Project	IEEE 802.16 Broadband Wireless Access Working Group < http://ieee802.org/16 >	
Title	Enhanced Paging with Assigned Ranging Code – Harmonization Ad-hoc Consensus Contribution	
Date Submitted	2004-08-28	
Source(s)	Hang Zhang, Mo-Han Fong, Jianglei Ma, Peiying Zhu, Wen Tong Nortel Networks	mhfong@nortelnetworks.com
	Inkyu Paek Hanarotelecom	inkyu@hanaro.com
	Chulsik Yoon ETRI	csyoon@etri.re.kr
	Itzik Kitroser Runcom Technologies	itzikk@runcom.co.il
	Philip Barber Broadband Mobile Technologies, Inc.	pbarber@BroadbandMobileTech.com
Re:	IEEE P802.16e/D4-2004	
Abstract	This contribution proposes enhanced paging by assigning dedicated ranging resource	
Purpose	Review and Adopt the suggested changes into P802.16e/D4	
Notice	This document has been prepared to assist IEEE 802.16. It is offered as a basis for discussion and is not binding on the contributing individual(s) or organization(s). The material in this document is subject to change in form and content after further study. The contributor(s) reserve(s) the right to add, amend or withdraw material contained herein.

Fig. 2. The proposed solution.

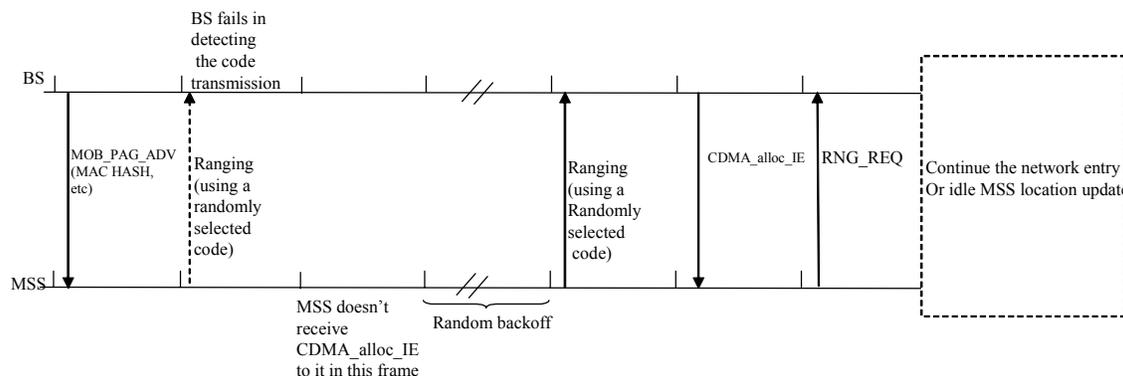
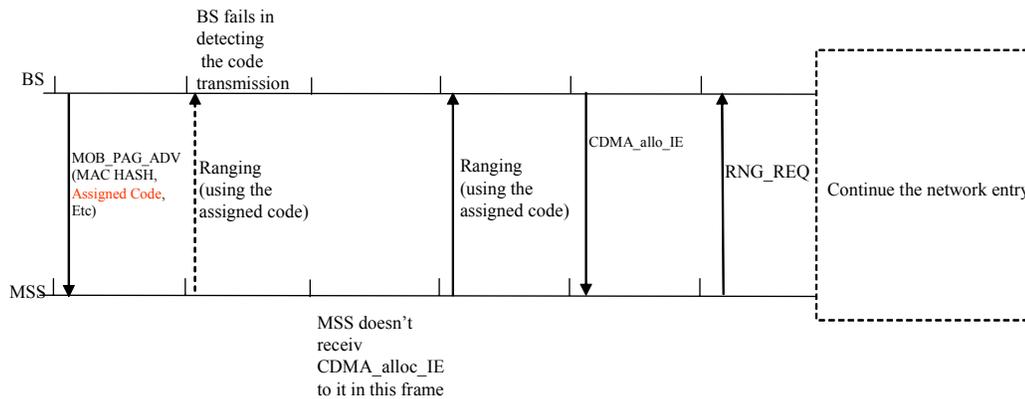
In current paging procedure, after a MSS receives MOB_PAG_ADV message with its MAC hash included, the MSS will perform normal OFDMA based ranging operation. A back-off is required for collision resolution if a MSS doesn't receive an expected CDMA_alloc_IE with resource assignment.

In the proposed solution, when a BS in the paging group assigns the ranging resource (i.e., code by MOB_PAG-ADV and region by UL-MAP in the next frame), the paged MSS shall send the assigned ranging code in consecutive frames during the page-response window (a parameter defined in MOB-PAG-ADV message). If the MSS receives a RNG-RSP message with status set to 'continue', before the end of the page-response window, the MSS shall stop consecutive frame transmission of the assigned ranging code and respond by a single transmission of the assigned ranging code with adjusted time, power and frequency based on the information received in the RNG_RSP message. The MSS shall continue using the assigned ranging code to respond to each RNG_RSP message received, until a RNG_RSP with status set to 'success' is received. Once the MSS receives a RNG_RSP message with status set to 'success', the MSS shall stop transmitting the assigned ranging code and wait for the CDMA_Allocation_IE() to send RNG_REQ message.

After a transmission of the assigned ranging code, if the MSS does not receive a RNG-RSP message after a certain period (T3), the MSS shall perform normal initial ranging procedure to respond to the paging (i.e., the assigned ranging resource is no longer valid). On the BS side, if after paging a MSS with assigned ranging code and region, the BS receives the code transmitted by the paged MSS, the BS shall send RNG-RSP to adjust time, power and frequency of the MSS. If the BS does not receive the expected code from a paged MSS after the expiry of the page-response window, the assigned ranging resource shall be automatically released.
